PREVOST

95-02

Warranty Bulletin

Date: **January 1995**
Section: **23**
Subject: **INSTALLATION OF A RAIL IN THE LAVATORY COMPARTMENT WINDOW**

Figure 1

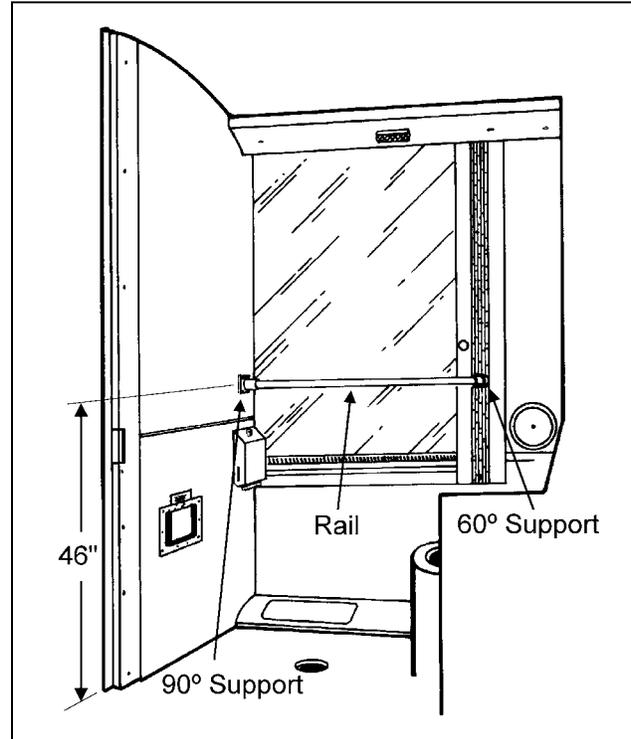
On all the above-mentioned vehicles, you must fix a rail in the lavatory compartment window to help passenger to keep balance when vehicle is moving. The rail, facing the "LE MIRAGE" type window, is fixed to the window post and to the front inside wall. To perform this modification, proceed according to the following procedure and use the material listed below.

2. Use the 90° rail support as a template and mark the location of the 4 holes on front wall at an approximate height of 46" (1,15 m). See figure 1.

6. Slide the 60° support on rail, thread in set screw on 60° support, then mark the 2 holes on the window post. See figure 1.

4. Fix the panel to the structure, use the 60° support as a template, mark the location of the two holes, then use a 9/64" (3,5 mm) bit and drill holes in panel and gusset. See figure 1.
